June 6, 2007

Re: Comments on Environmental Assessment for Two APDs Near Sespe Condor Sanctuary and Hopper Mountain National Wildlife Refuge

Figure 1: Map of Proposed Well Site in Relation to the Sespe Condor Sanctuary and the Hopper Mountain National Wildlife Refuge

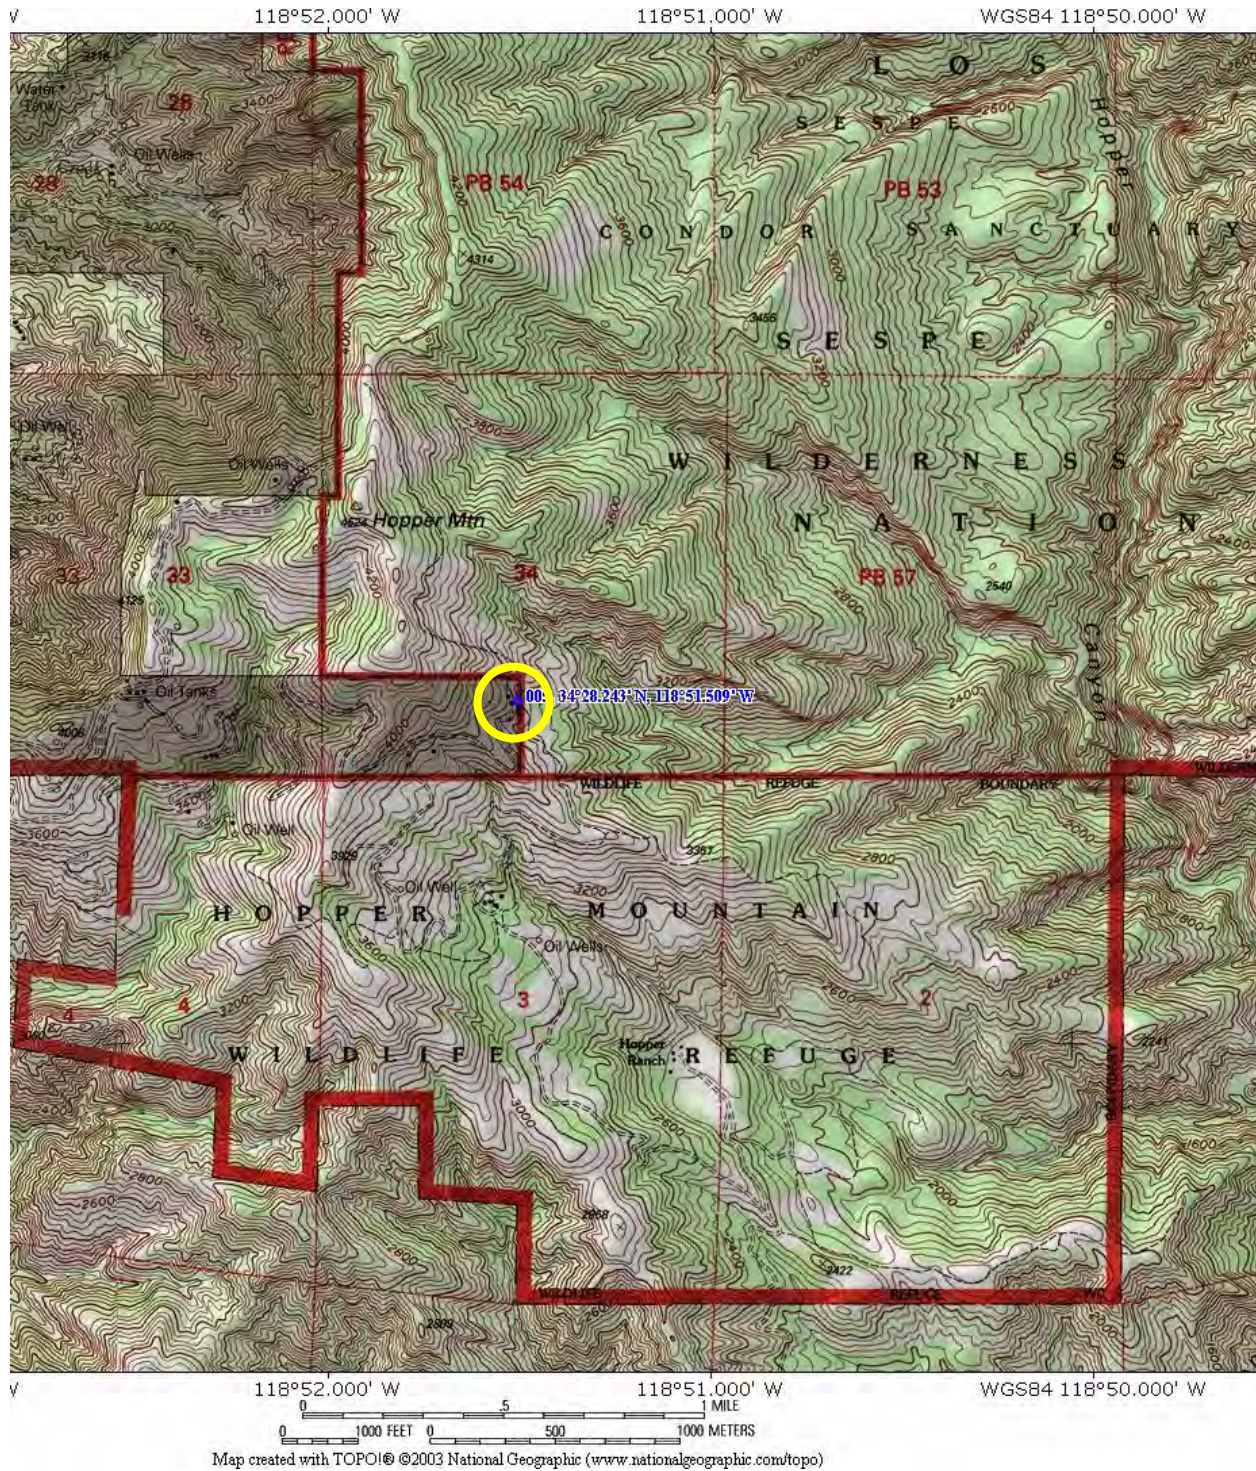
As you know, the subject of these APDs and EA is a proposal by Seneca Resources to drill two new wells on an existing well pad on Hopper Mountain. The pad is located on a narrow sliver of private land within the boundary of the Los Padres National Forest, between the Hopper Mountain National Wildlife Refuge and the Sespe Condor Sanctuary. The well pad currently holds at least 13 oil wells, none of which have ever undergone environmental review under the National Environmental Policy Act (“NEPA”). This pad and the proposed wells are located along the edge of the Sespe Condor Sanctuary and less than a quarter-mile from the Hopper Mountain National Wildlife Refuge (see Figure 1, attached).

The proposed well site is surrounded by the edge of the Sespe Condor Sanctuary on two sides, and by the Hopper Mountain National Wildlife Refuge on a third side. Specifically, the site is located on, or immediately adjacent to, the boundary of the Sespe Condor Sanctuary, and is within less than a quarter-mile of the boundary of the Hopper Mountain National Wildlife Refuge. The sanctuary is designated by the federal government as critical habitat for the endangered California condor. Both the sanctuary and the refuge serve as critical components of the California Condor Recovery Program, and are closed to public entry.
